# ADDENDUM No. 2

## RFP No. 24-34

## Motor Control Centers E & F Replacement

## ELECTRICAL ROOM PLAN - EL. 758

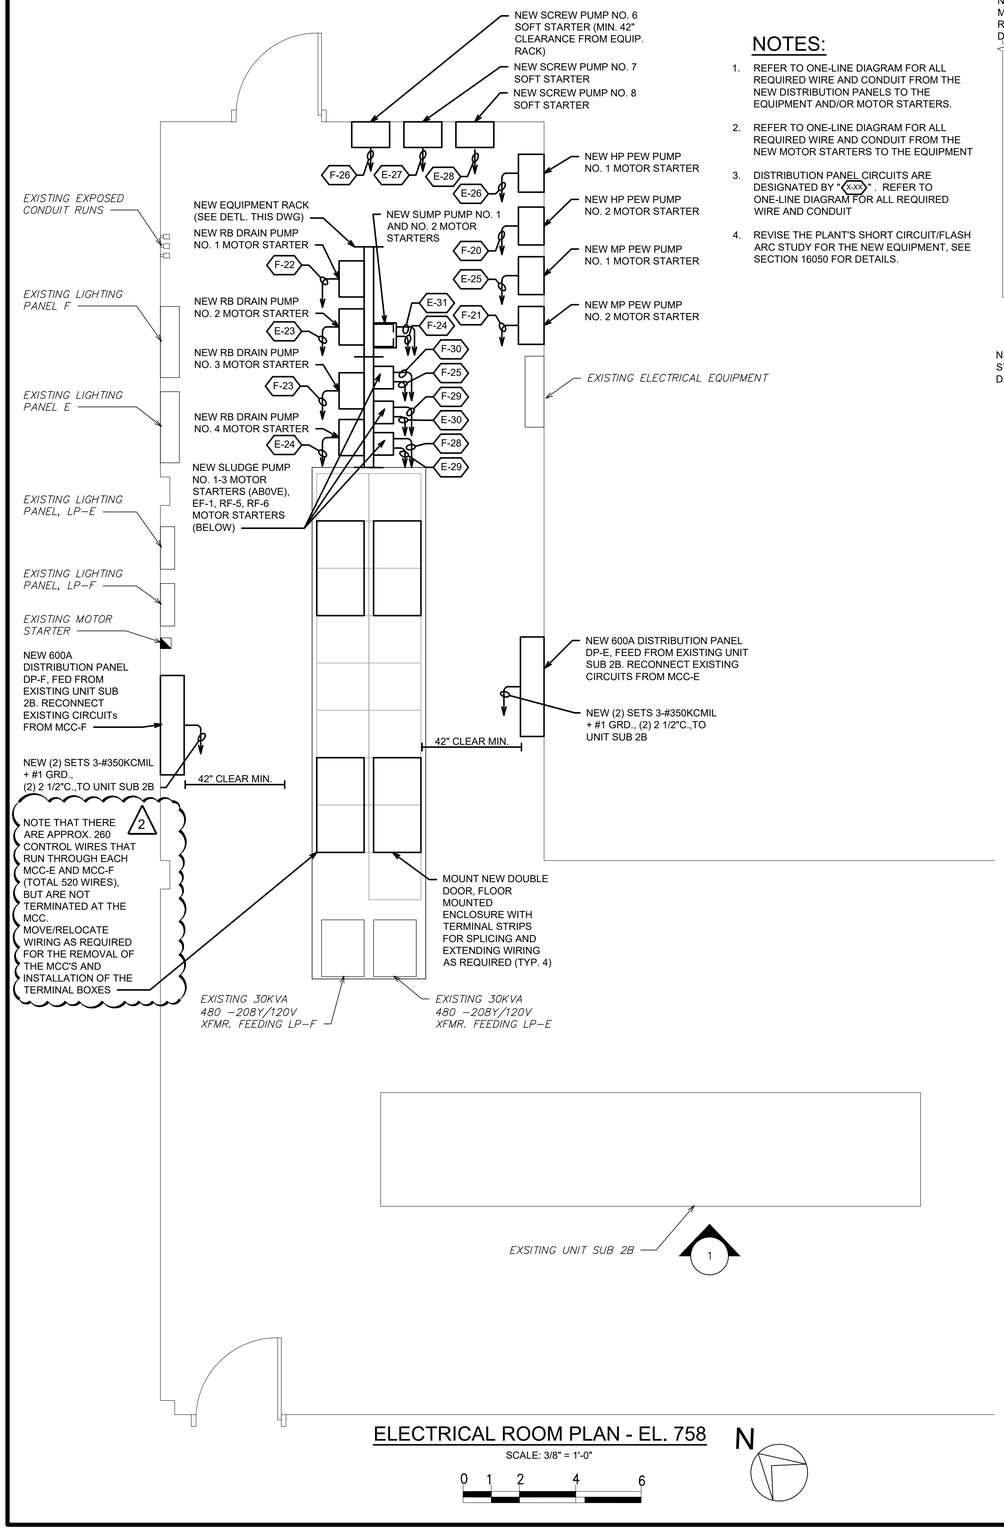
**Add** Clarification for control wiring inside MCC-E and MCC-F.

Question 9: Drawing E-02 contains a note stating the following: "note that there are approx. (260) control wires that run through MCC-E and MCC-F, but are not terminated at the MCC. Confirm that this Approximate quantity of (260) control wires is for Each MCC for a total of (520)., HVE has located archived plans from prior project 2011 where in these drawing we have identified the following quantity of control wires: MCC-E (396)-#14 and MCC-F (264)-#14. Please provide confirmation on the quantity of existing control wires.

Answer 9: An exact quantity must be determined in the field, but based on the information available, assume approximately 260 wires per MCC for a total of (520). Revised Drawing E-2 is attached. The prior project drawings have also been attached as a reference.

## TYPICAL EQUIPMENT RACK DETAIL

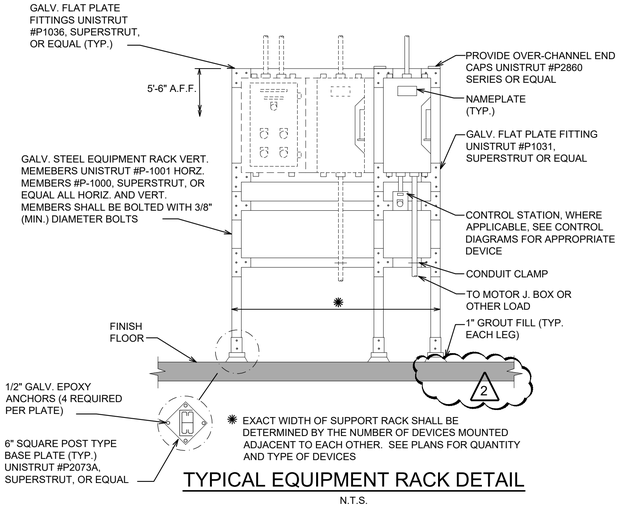
**Remove** Ground conductor to equipment rack.

Question 8: Plan drawing E-02 contains a detail 'Typical Equipment Rack' Calling for a #2 AWG grounding conductor bonded to the equipment rack. Please provide information on where the source connection for this grounding/bonding conductor is to be

connected. With the MCC's removed, the ground bus in these units are removed. There was no exterior ground bus bar identified within the electrical room for the bonding source for the grounding conductor. Please provide information on where these grounding/bonding conductors are to connect to a grounding source.

Answer 8: Delete separate ground conductor to equipment rack.
